C ALDWELL, R ICHARDS & S ORENSEN, INC.

Subject: Soil Investigating and Reporting on Dam at Shootering, Utah  
CRS Project #25-1033

# SIMPLIFIED LIQUEFACTION

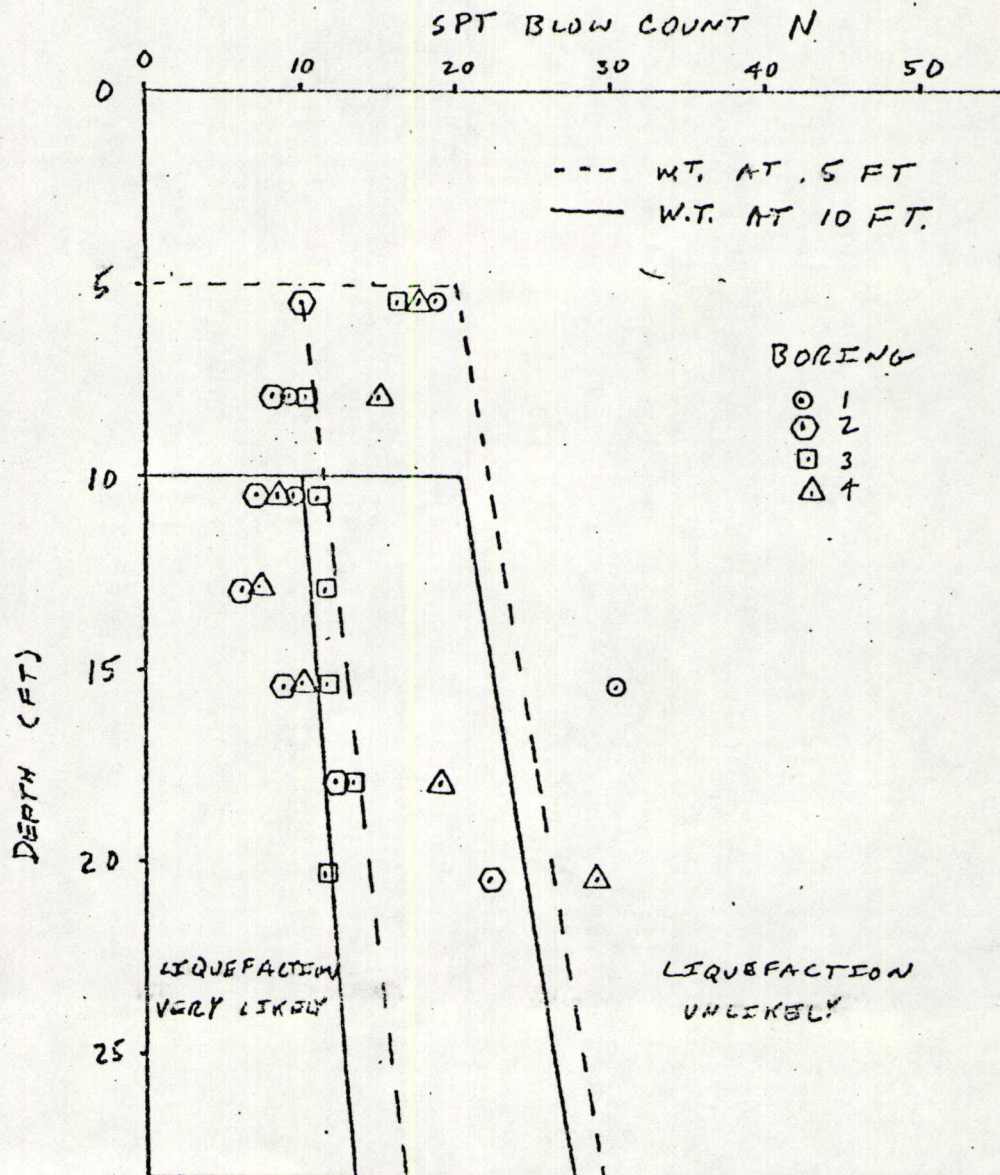
Such a procedure has been applied to the dam at Shootery using the data from the Caldwell, Richards and Sorensen report. The attached figure shows envelopes assuming the ground water level is at 5 feet and 10 feet below the ground surface together with the SPT results from Shootery. The envelopes divide the plot into three sections: liquefaction very likely, liquefaction very unlikely and an intermediate zone where liquefaction potential depends upon the soil type and the magnitude of earthquake shaking. For the poorly graded silty sands at Shootery and the zone 3 earthquake potential in Utah, the true envelope would be closest to the liquefaction unlikely zone.

This simplified procedure indicates a high susceptibility to liquefaction with 92% of the points indicating soils likely to liquefy. Because the borings were taken at the centerline of the dam where confinement and relative density would be expected to be highest, other portions of the dam would be expected to be at least as susceptible to liquefaction.

However, susceptibility to liquefaction may be limited by keeping the free water surface low in the dam. Providing an adequate impervious barrier at the upstream face may prove adequate to eliminate the liquefaction potential.
